MEMORANDUM

Date: January 06, 2015
To: David Bonk, Kumar Neppalli, PE
Town of Chapel Hill, North Carolina
From: Bill Schultheiss, PE
Re: South Columbia Street and Otey's Road Safety Review and Concept Development

Toole Design Group (TDG) was retained by the Town of Chapel Hill to review a concept design developed by Kimley-Horn and Associates, Inc. (KHI) at the northern intersection of South Columbia Street at Fordham Boulevard (attached as exhibit 2), to develop concept design alternatives for South Columbia Street from Purefoy Road to Culver Road, and to develop a crossing improvement concept for Otey's Road at Fordham Boulevard.

Existing pedestrian and bicycle access and safety challenges

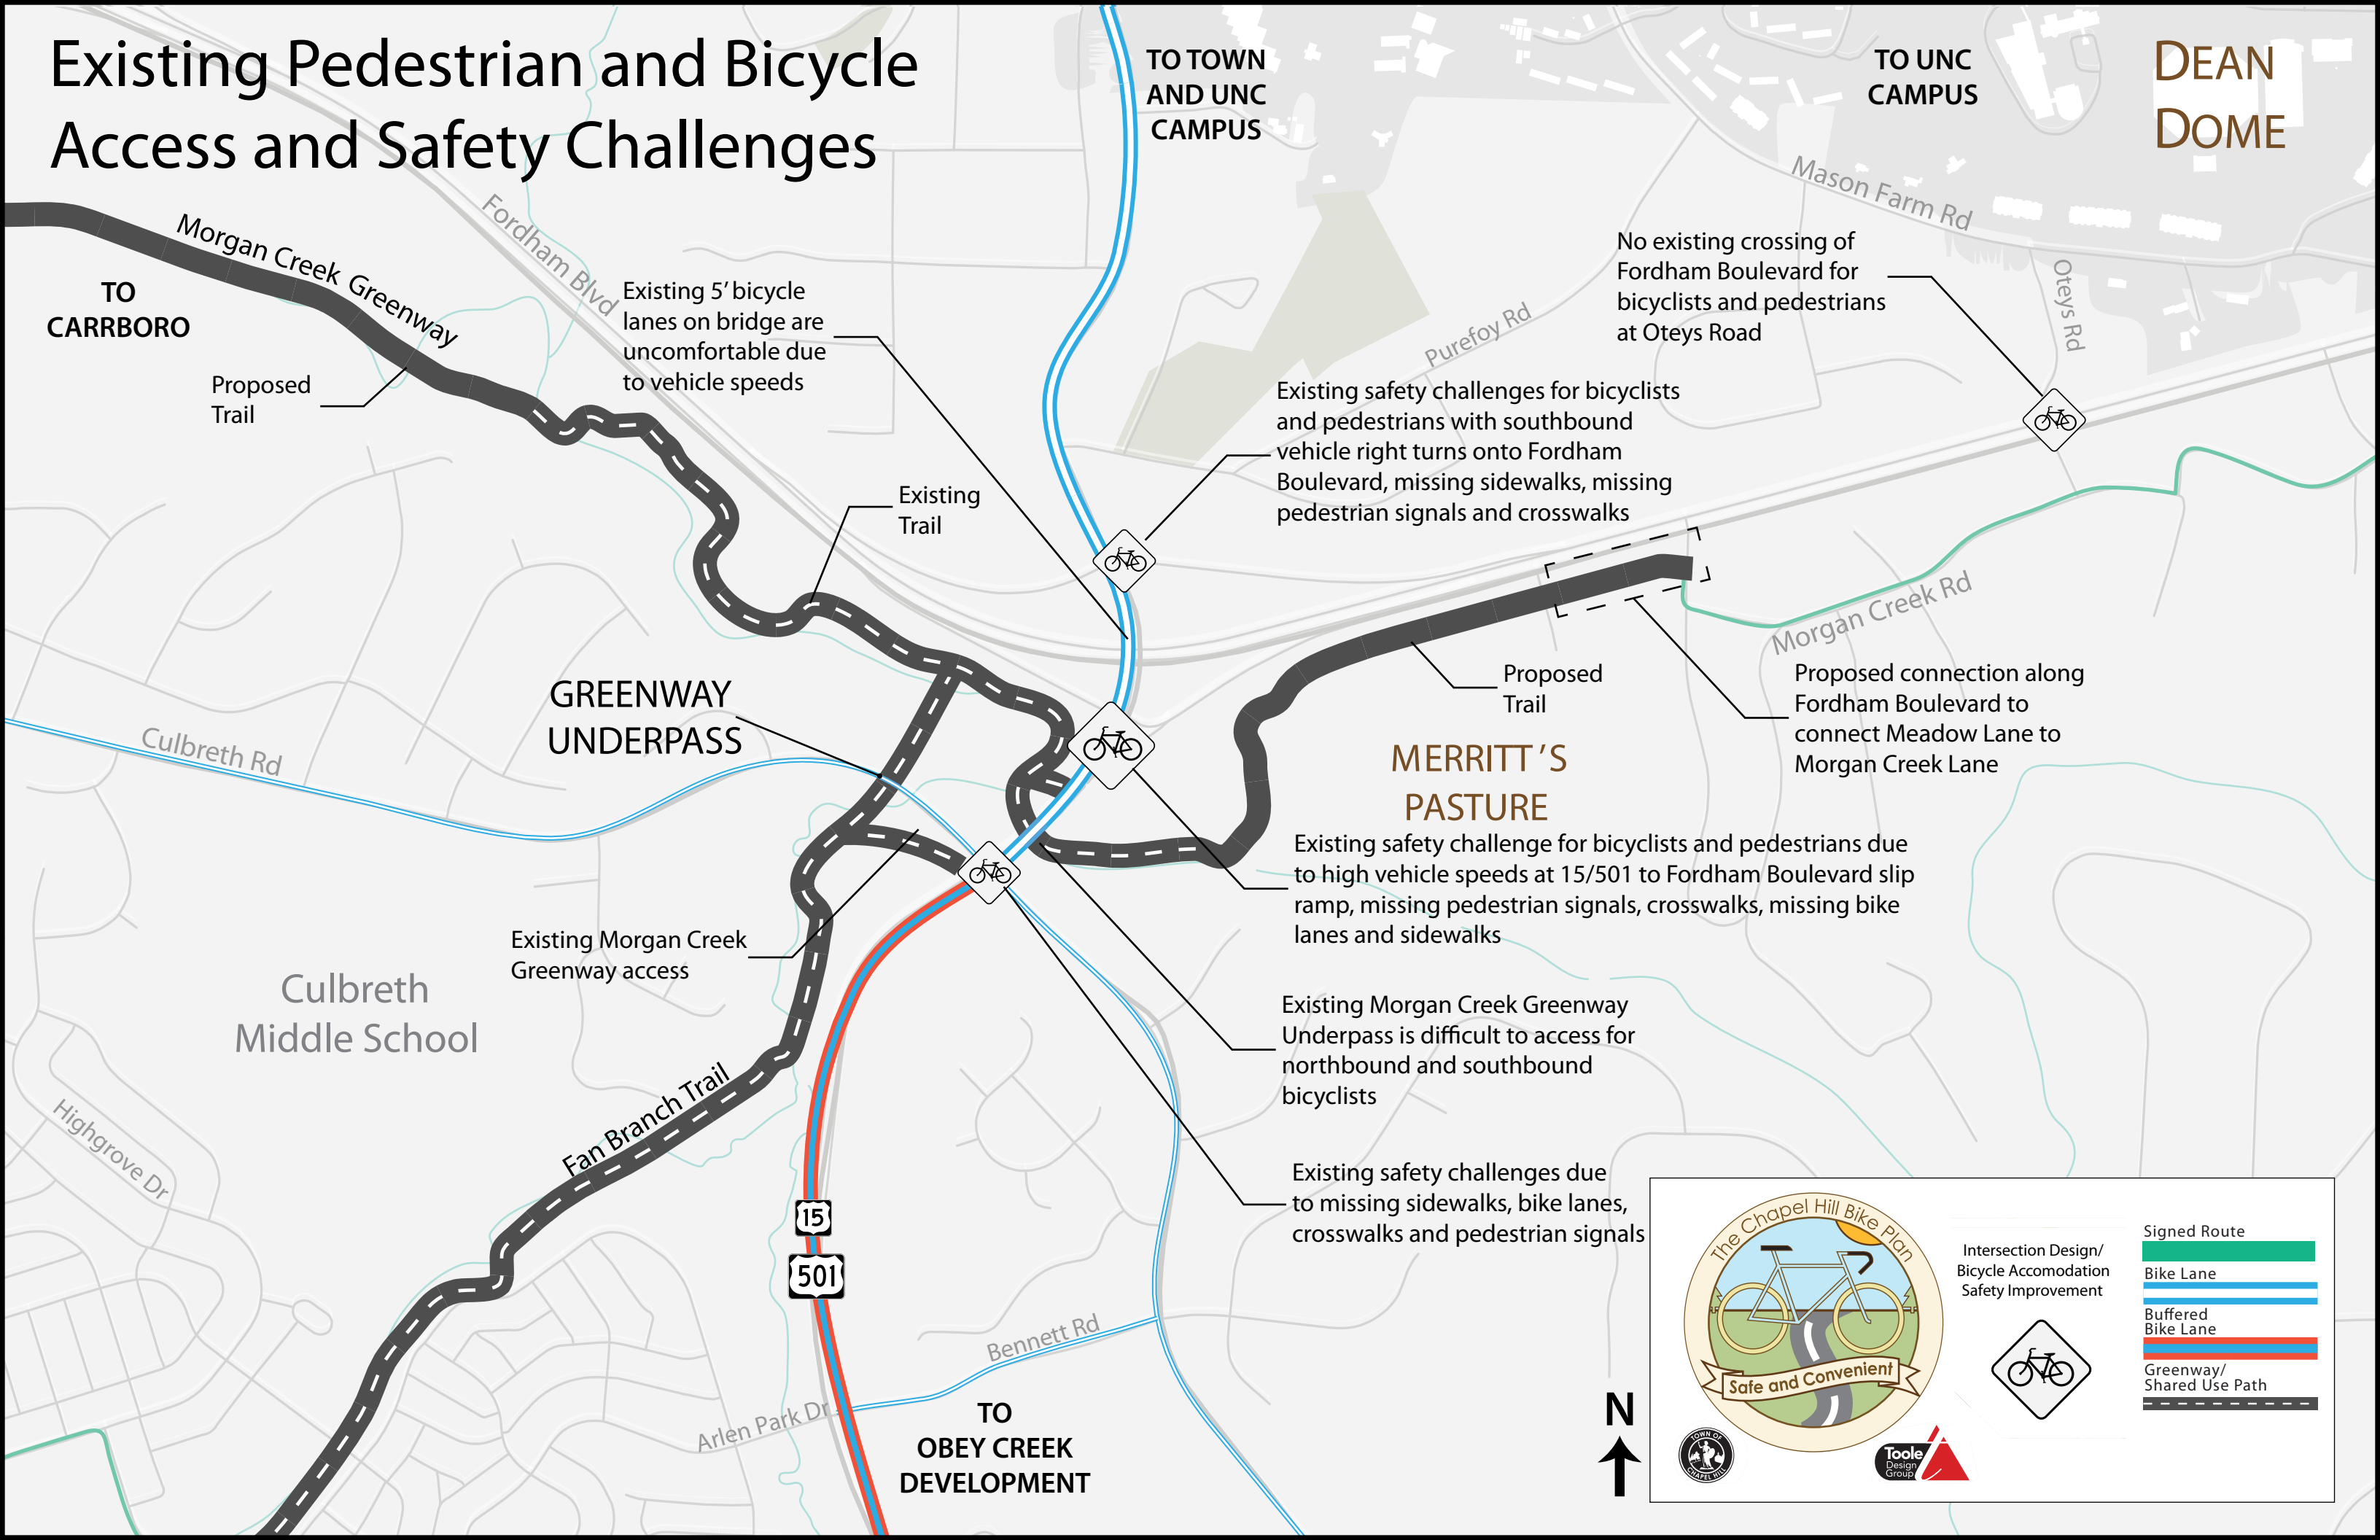
With increasing development south of Fordham Boulevard at Southern Village and Obey Creek, additional bicycle and pedestrian traffic is anticipated. The North Carolina Department of Transportation (NCDOT) recently widened South Columbia Street north of Purefoy Road to add bicycle lanes and sidewalks on both sides of the street. The Chapel Hill bicycle plan identified the intersections with the Fordham Boulevard entrance and exit ramps as locations in need of spot improvements for bicyclist safety. These intersections are designed with large curb radii exposing bicyclists to high speed motorist conflicts. These intersections also have an incomplete pedestrian network (sidewalks, curb ramps, crosswalks, signals). **Exhibit 1 illustrates key access and safety challenges for bicyclists and pedestrians.** Additional safety challenges include:

- Absence of street lighting along South Columbia Street
- Missing sidewalks along the east side of the street south of Fordham Boulevard
- Free flow right turn lane that allows high speed turns for northbound right turn onto Fordham Boulevard
- The size of the intersections increase exposure of bicyclists and pedestrians to turning traffic and allow traffic to turn at higher speeds
- Incomplete trail connections through Merritt's Pasture to allow alternate route to UNC Campus via Morgan Creek Road
- Missing crossings to allow pedestrians and bicyclists to cross South Columbia Street
- Unclear delineation of bicyclists path through merging areas reduces clarity of right-of-way at start of right turn lanes

The deficiencies identified in Exhibit 1 are based on direct observation by TDG staff, a review of the proposed KHI alternative, and input provided from the public through the Town and University Bike Plans.

SHEET NAME:
S. COLUMBIA AT
FORDHAM BLVD
WESTBOUND RAMP
DRAWING NUMBER
SK-1
SHEET NUMBER
1 OF **13**

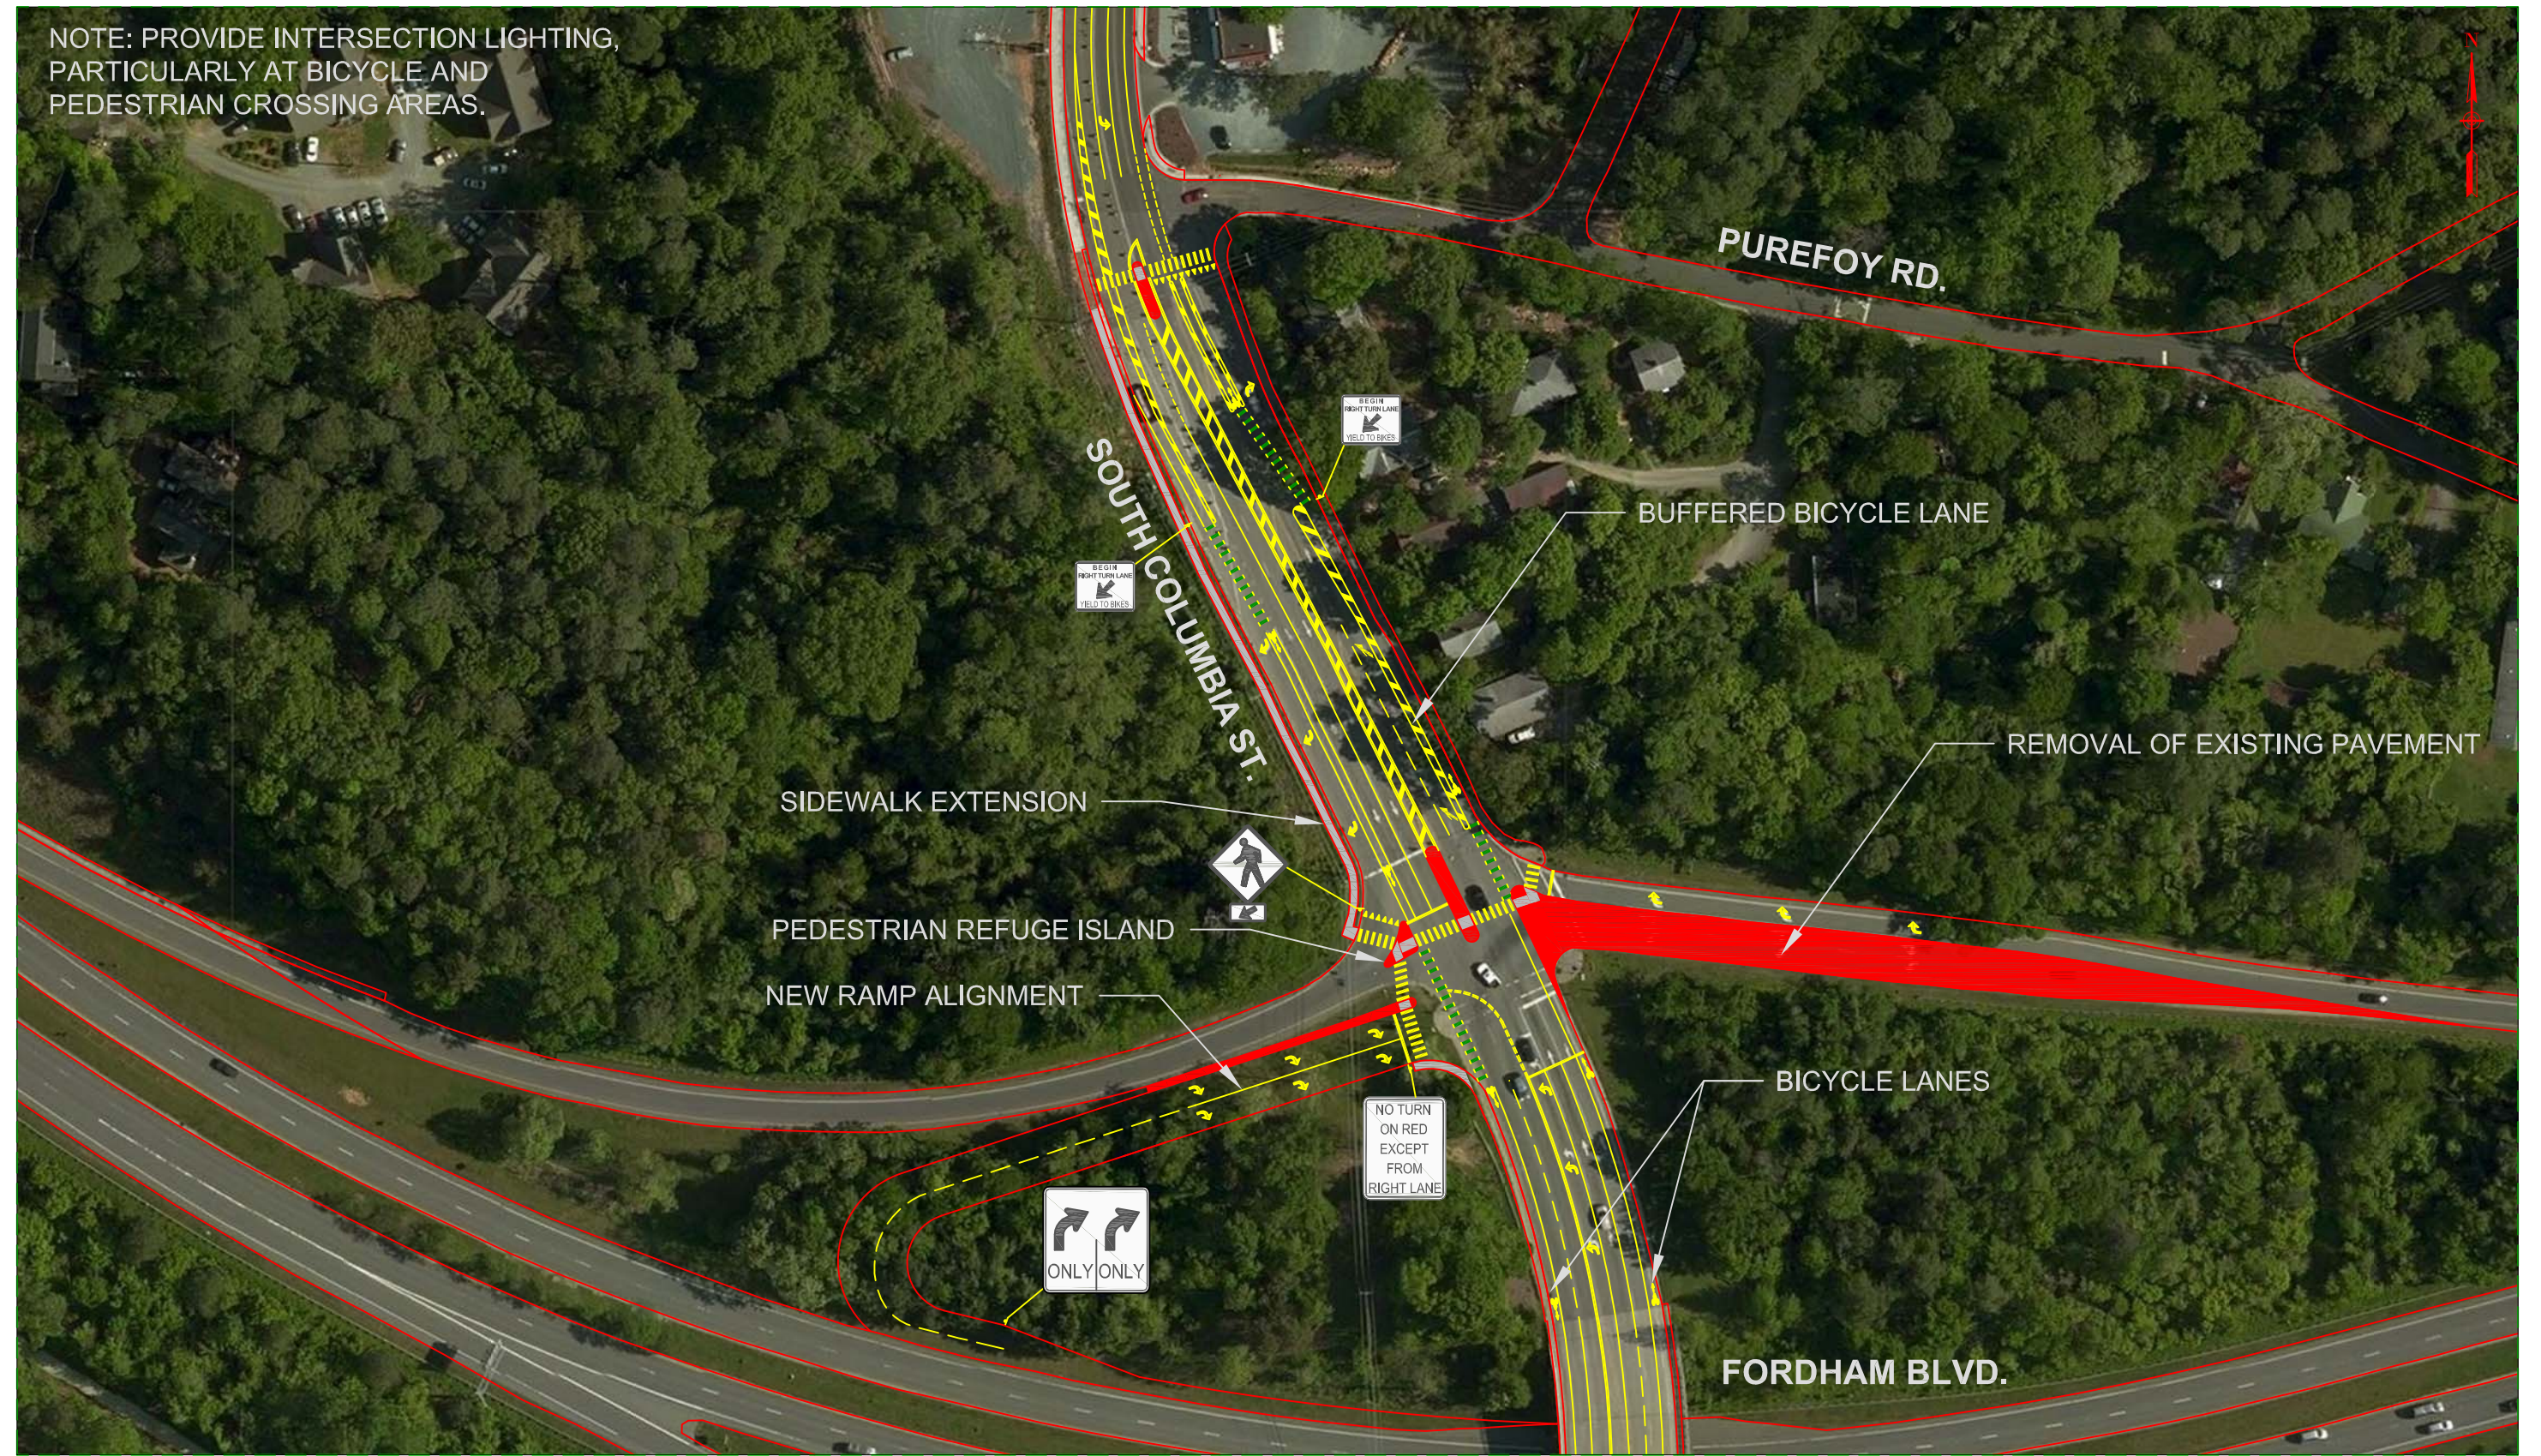
Alternative 1 depicts modest changes to the KHI design. The slip ramp designs remain in place for the southbound and northbound on-ramps to Fordham Boulevard. Adjustments to curbs are recommended to remove free flow traffic from the proposed westbound to southbound off ramp.

- Signal, stop control, or yield control for each on and off ramp is recommended in that prioritized order of consideration to ensure pedestrians and bicyclists have safe crossing opportunities;
- Modify intersection geometry for the northern intersection of South Columbia Street at Fordham Road to:

- allow a WB-62 to utilize the full width of the receiving roadway for turns, (recognizing this is a small percentage of the traffic);
- consider restriction of right-turn-on red for trucks which will need larger gaps in traffic if the dedicated receiving lane is not provided;

- to reduce likelihood vehicles queue into the through lanes on Fordham Boulevard⁵ the westbound to southbound off ramp provides a double right turn lane (shown on concept); this may require this may require trucks to control both lanes to make the right turn;

- It may be further necessary to lengthen the deceleration lane from Fordham Boulevard east of the the South Columbia Bridge. It appears space is available if the travel lane can be located in close proximity to the existing bridge support column.

- A median refuge is provided for the new northern crosswalk;
- Modify intersection geometry for the southern intersection of South Columbia Street at Fordham Boulevard;
